PRODUCT / PROCESS CHANGE INFORMATION

1.1 Company		STMicroelectronics International N.V
1.2 PCI No.	ADG/18/10755	
1.3 Title of PCI	SOT-223 (Large die pad): Lead frame Additional Supplier Introduction (PSJ - Poongsan Sanjia)	
1.4 Product Category	VNL5050N3TR-E, VNN7NV04PTR-E	
1.5 Issue date	2018-03-01

SOT-223 (Large die pad): Lead frame Additional Supplier Introduction (PSJ - Poongsan Sanjia)

Lead Frame Comparison

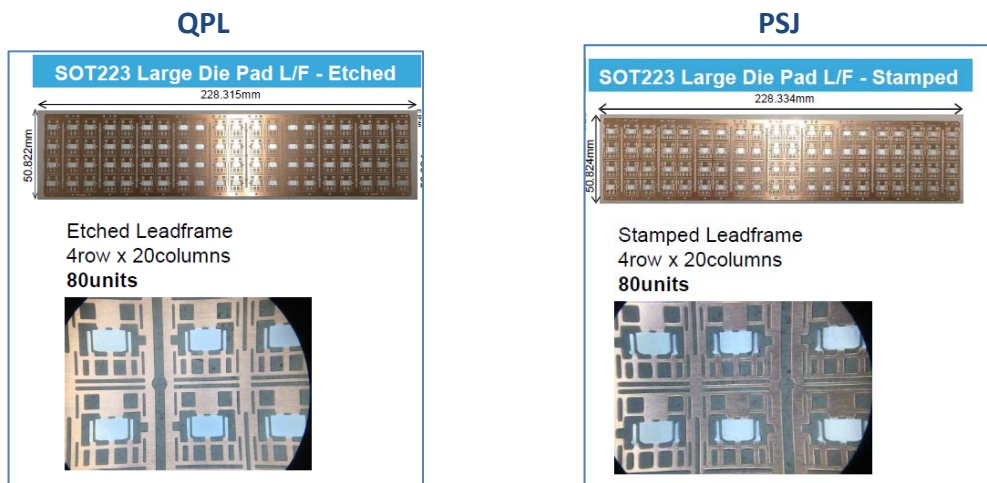
Please be informed that a second source supplier for lead frame (**PSJ - Poongsan Sanjia**) has been qualified for Products housed SOT-223 package version beside current QPL
